# Town of Jay - Town Hall ADA Improvements

### ADDENDUM NUMBER 001

**1.01 DATE: 2023-10-24**

**1.03 PROJECT NUMBER: 23061**

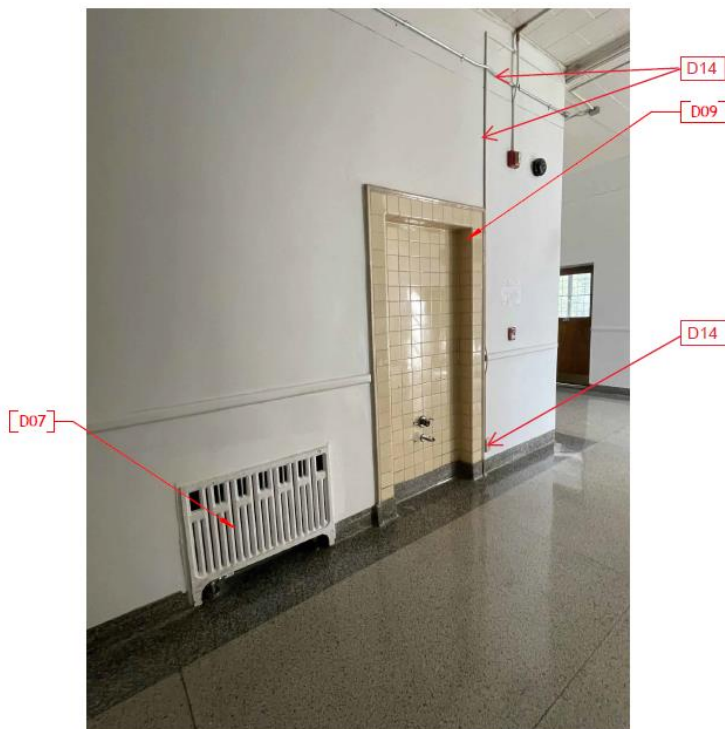
2. **ADD** Keynote D14: ISOLATE, MODIFY & RELOCATE EXISTING DUPLEX RECEPTACLE, WIREMOLD AND EMT CONDUIT NEXT TO CERAMIC TILED OPENING FOR DRINKING FOUNTAIN. RELOCATE APPROXIMATELY LEFT OF NEW OPENING. VERIFY LOCATION WITH OWNER/ARCHITECT PRIOR TO INSTALL. (SEE PHOTO BELOW)
